#### New Albany Architectural Review Board Meeting Agenda Monday, April 14, 2025 7:00 p.m.

#### **ARB-80-2024** Certificate of Appropriateness

STRATEGIC PLAN: Village Center APPLICATION: ARB-80-2024

STRATEGIC PLAN: Village Center APPLICATION: ARB-15-2025

DATE: 03.25.25 SALESMAN: Dar DESIGNER: Scot DRAWING #02

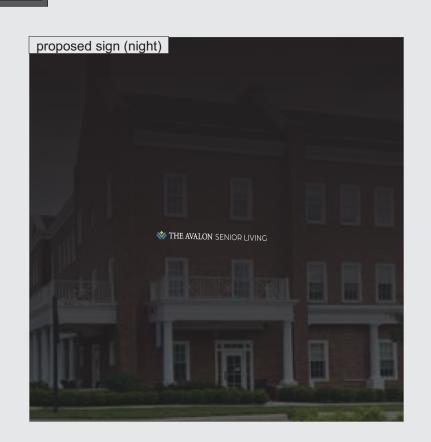
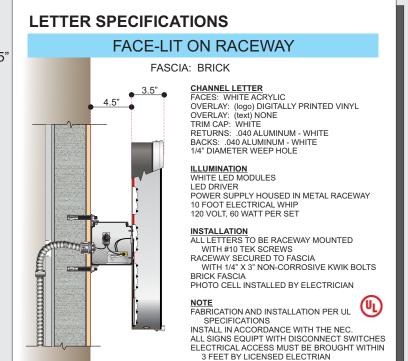
Letter size and thickness may be too small for illuminated channel letters as shown.

## FACE-ILLUMINATED, RACEWAY-MOUNTED CHANNEL LETTERS - (Qty. 1)

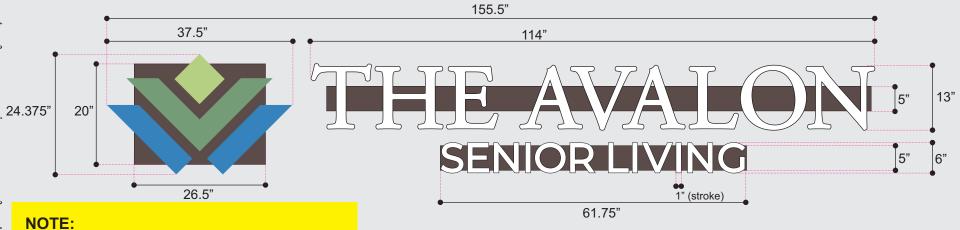
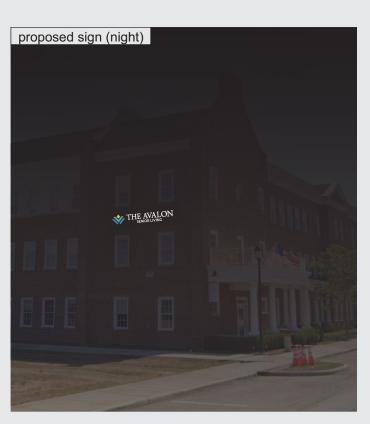
Letter size and thickness may be too small for illuminated channel letters as shown.
